Subject: FW: N of Summer Lane P/35/20/DOC & P/37/20/DOC

Subject: N of Summer Lane P/35/20/DOC & P/37/20/DOC

We have the following comments regarding the revised surface water drainage details submitted for P/35/20/DOC and P/37/DOC.

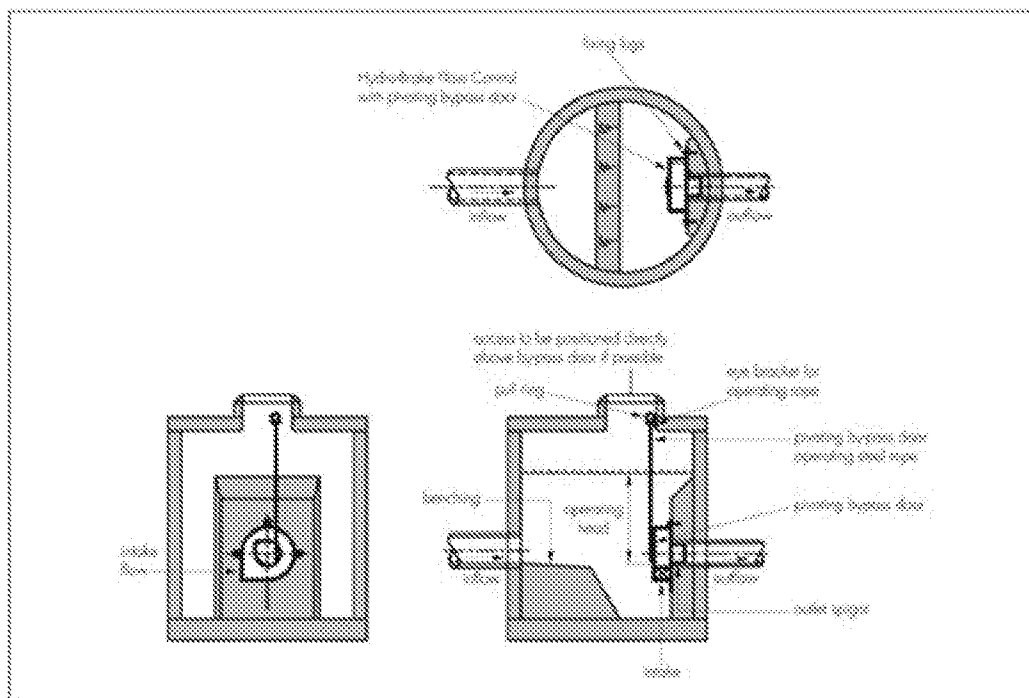
3. Provide full details of the proposed remediation works to the northern ditch and Crayfern outfalls. – reference to be made to the OWC application and associated OWC response 22/05/2020 *Cutting of headwall aprons and treating exposed reinforcement unlikely to provide a good long term solution, who is then going to be responsible for maintenance, if this is Crayfern then all proposals will require their approval too. Reconstruction may be better. Please provide details of anticipated design life of net gabions. Provide details of how future maintenance of ditches with this reinforcement will be undertaken- risk of damage. Have these proposals been run by an ecologist?*
